**KING DRIVE**  
**SUBDIVISION OBSERVATION REPORT**

**July 25, 2012**

**HR GREEN JOB NO. 86120056**

KING DRIVE  
 POND A

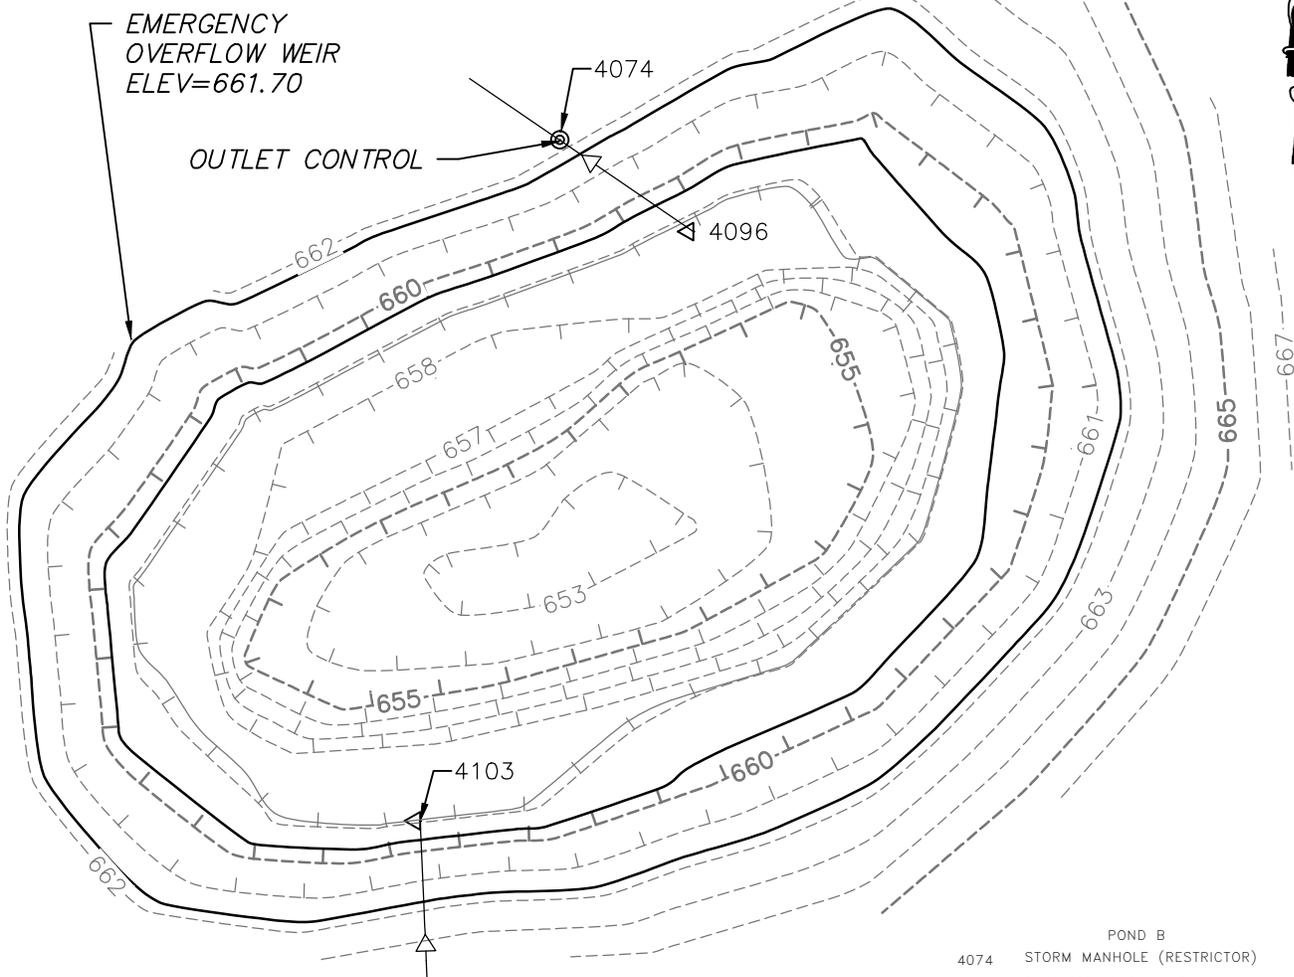
<b>POND A</b>			
	<b>PROPOSED</b>	<b>EXISTING</b>	<b>DIFFERENCE</b>
WEIR WALL– TOP ELEV.	656.44	656.62	0.18' HIGH
2 YEAR RESTRICTOR INV ELEV. (diameter)	654.50 (6.82")	654.12 (7.5")	0.38' LOW (1.5" TO LARGE)
100 YEAR RESTRICTOR INV ELEV. (diameter)	654.80 (3.68")	654.22 (4")	0.58' LOW (0.32" TO LARGE)
100 YEAR EMERGENCY OVERFLOW WEIR ELEV.	657.10	656.10 (HWL)	1.0' LOW

<b>POND A</b>			
	<b>PROPOSED</b>	<b>EXISTING</b>	<b>DIFFERENCE</b>
NWL	654.50	654.10	0.40' LOW
HWL	657.10	656.10	1.00' LOW
STORAGE VOLUME (AC.FT.)	0.536	0.422	0.114 Shortage

In Pond A the diameter of the 2 year restrictor orifice was constructed 1.50" larger than was proposed. The 100-year restrictor orifice was constructed 0.32" larger than was proposed. These deviations would result in a stormwater release rate that is greater than the rate proposed. The 100-year emergency overflow was constructed 1.0' lower than the proposed elevation. This results in a reduced storage volume for the basin. This basin does not comply with the design plans. A detailed review of the original drainage calculations or a hydraulic analysis would be required to determine the impact of these deviations.

KING DRIVE  
 POND B

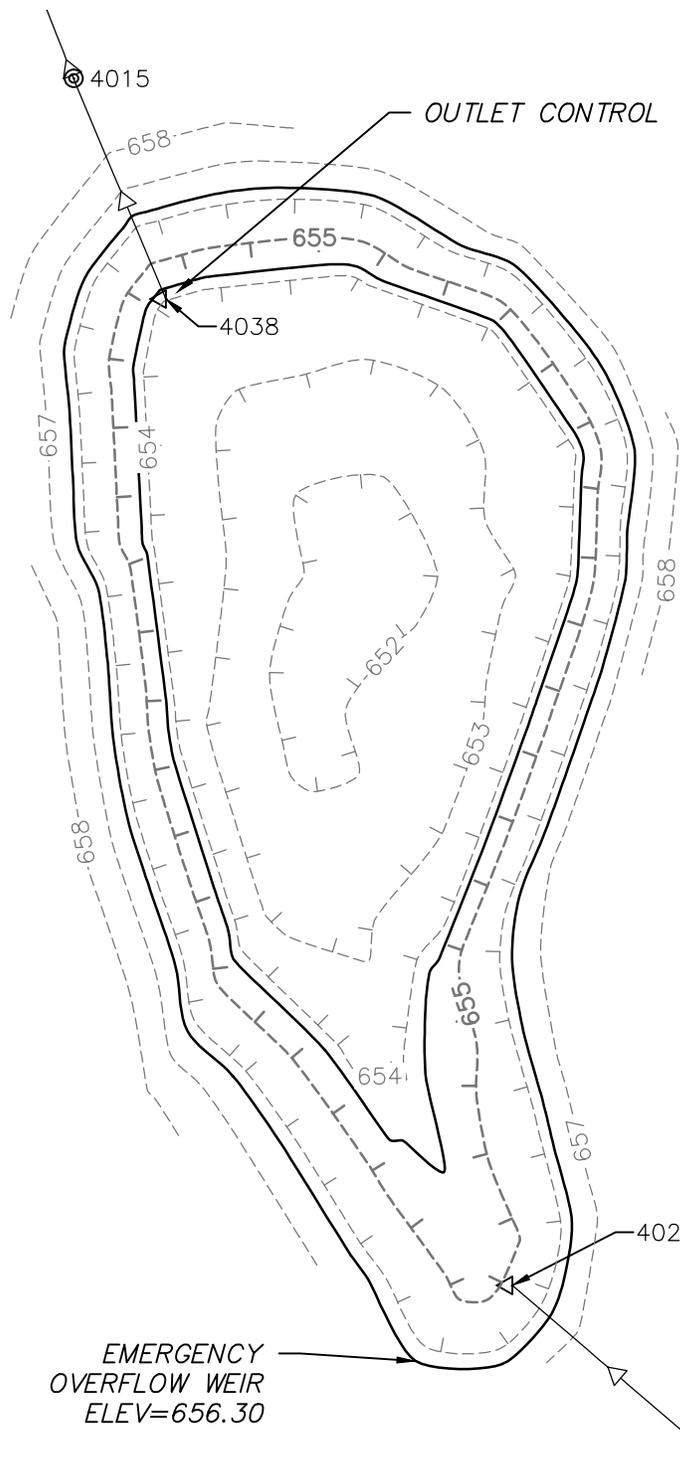
<b>POND B</b>			
	<b>PROPOSED</b>	<b>EXISTING</b>	<b>DIFFERENCE</b>
WEIR WALL– TOP ELEV.	660.84	661.71 (HWL)	0.87' HIGH
2 YEAR RESTRICTOR INV ELEV. (diameter)	659.50 (3")	659.58 (3")	0.08' HIGH
100 YEAR RESTRICTOR INV ELEV. (diameter)	659.80 (3")	659.63 (3")	0.17' LOW
100 YEAR EMERGENCY OVERFLOW WEIR ELEV.	661.50	661.80	0.30' HIGH

<b>POND B</b>			
	<b>PROPOSED</b>	<b>EXISTING</b>	<b>DIFFERENCE</b>
NWL	659.50	659.60	0.10' HIGH
HWL	661.50	661.70	0.20' HIGH
STORAGE VOLUME (AC.FT.)	0.474	0.570	0.096 SURPLUS

Pond B was proposed to be a wet pond. At the time of our survey it was not holding any water. This may be a result of the current dry conditions or the bottom of the pond may not be sealed properly. The differences noted above for Pond B do not result in negative impact on the storage volume or release rates for the pond. The pond is in general conformance with the design plans.
